**City of Portland, Oregon**  
**Bureau of Development Services**  
**Land Use Services**

## **NOTICE OF A TYPE II DECISION ON A PROPOSAL IN YOUR NEIGHBORHOOD**

### **CASE FILE NUMBER: LU 09-134284 AD**

The applicant plans to construct an Accessory Dwelling Unit (ADU) behind the existing house on this site. An ADU is a separate dwelling unit with its own cooking facilities. The ADU is designed so that it faces NE Skidmore Street. Approximately half of the side wall of the ADU is located 3 feet from the rear property line of this site with the remainder of this wall located approximately 5 feet from the property line. In the R2.5 zone the Portland Zoning Code requires structures over 6 feet in height to be located 5 feet from a rear property line. The ADU is also designed with a shed roof, a covered porch with a gabled roof, a combination of horizontal and vertical siding, as well as a combination of horizontal and vertical windows. The ADU is also designed with exposed rafter tails under the eaves and a privacy fence around the

SITE & FLOOR PLAN  
 A1.0

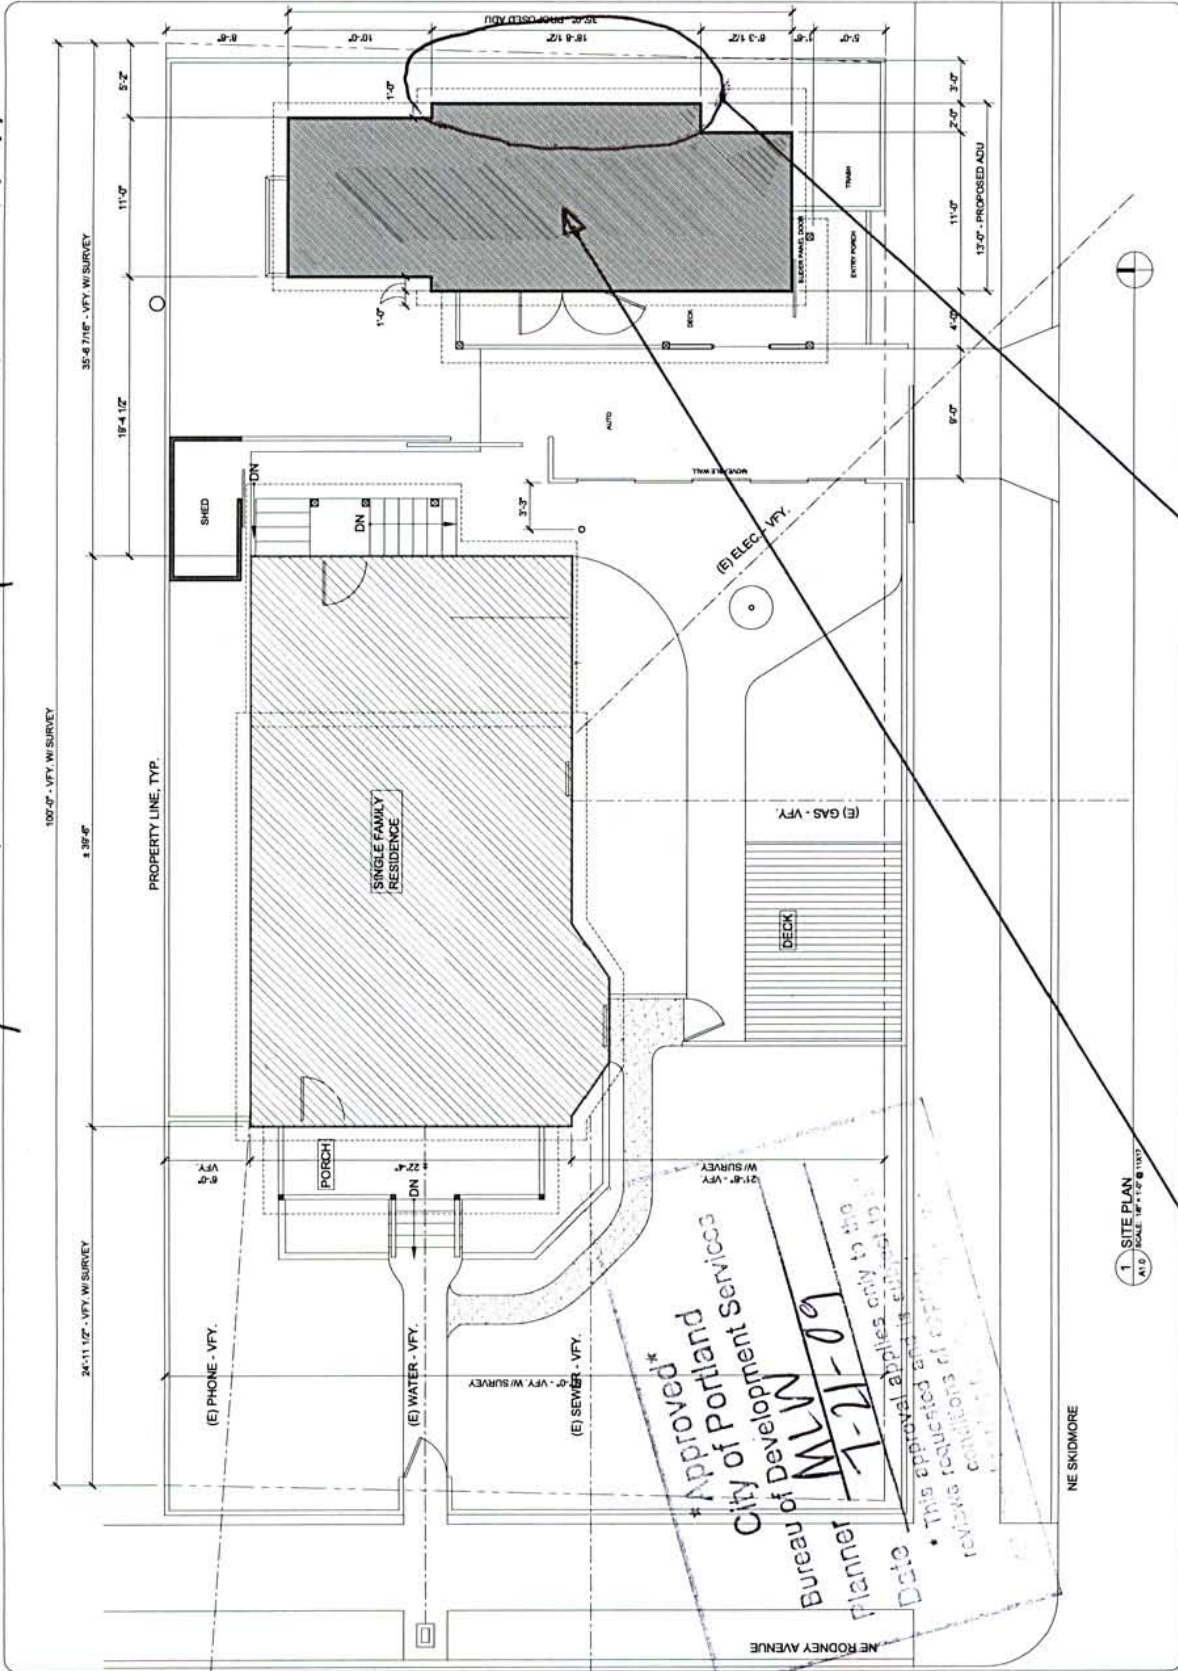
Adjustment request to reduce the rear setback from 5 feet to 3 feet for approximately 19 feet of planned ADU wall.

Location of proposed setback Adjustment

Approval of Adjustments to 33.110.220.B Setbacks and to 33.205.030.B Accessory Dwelling Unit Design Standards to allow the ADU to be located 3 feet from the rear property line and to allow architectural elements to vary from those of the existing house, per the approved site

PROPOSED ELEVATIONS  
**A2.0**

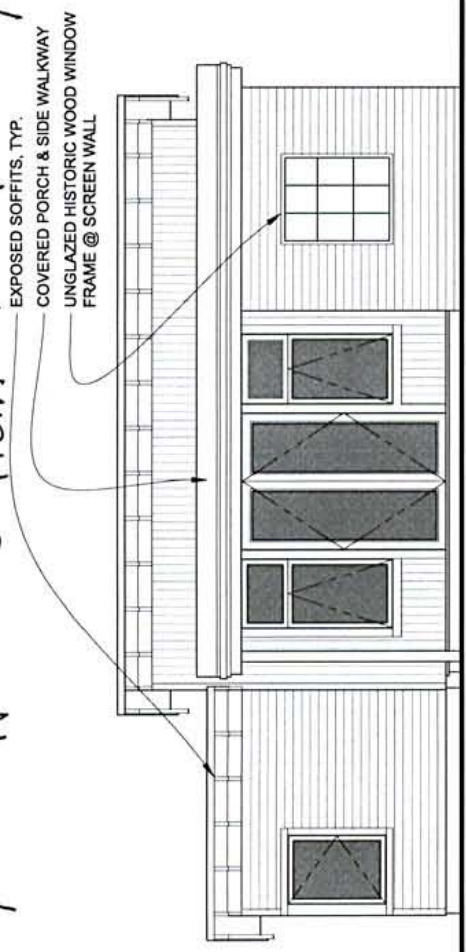
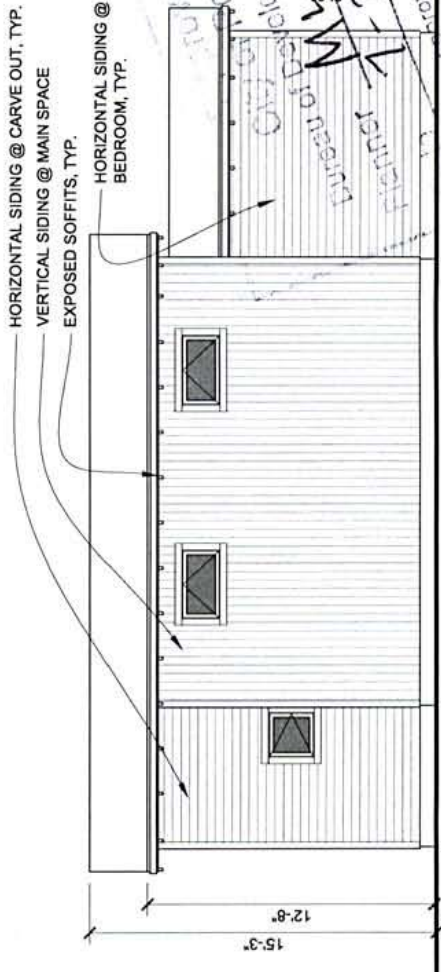
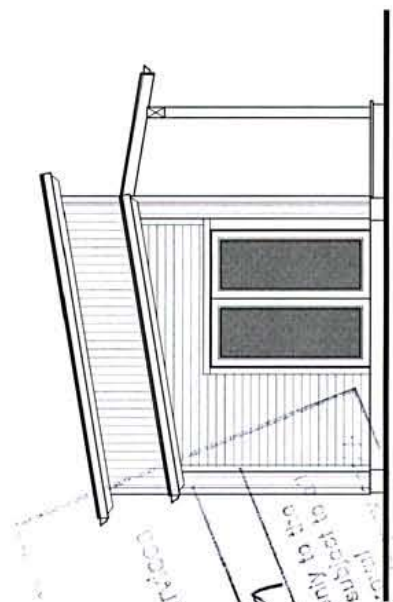
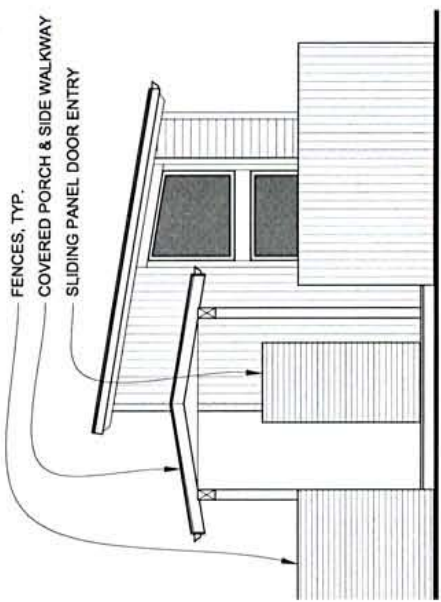
Adjustment request to allow certain architectural elements of the ADU, such as the roof pitch, siding, window orientation & trim, to vary in appearance from the primary residence.
